URGENT MEDICAL DEVICE CORRECTION

Baxter Healthcare Corporation is issuing an Urgent Medical Device Correction for the **Novum IQ** Large Volume Pump (LVP) and **Novum IQ** Syringe Pump (SP) due to software anomalies that may result in a blank Run screen (LVP and SP) and/or false motor movement system error (SP only).

*Figure 1. Red arrows point to load points 3 and 4 on the **Novum IQ LVP**.*

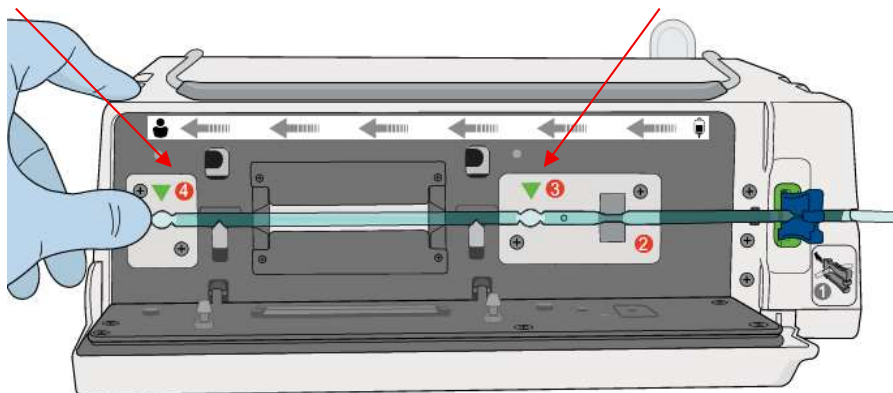
2. If an alternate pump is not available or appropriate for patient care involving high risk medications and/or critical illness, you may continue to use the **Novum IQ LVP** and **Novum IQ Syringe Pump** consistent with the following actions:
 - If a blank Run screen is displayed during an infusion on the **Novum IQ LVP**, the user should open the door, press the tubing into load point 3, then load point 4, to turn the light green (pictured in Figure 1 below), and close the door. If a blank Run screen is displayed during an infusion on the **Novum IQ Syringe Pump**, the user should unload, then reload the syringe. If these actions do not resolve the blank screen, both LVP and Syringe Pump users should power-cycle the pump, select “Yes” to the new patient prompt, and reprogram the infusion.
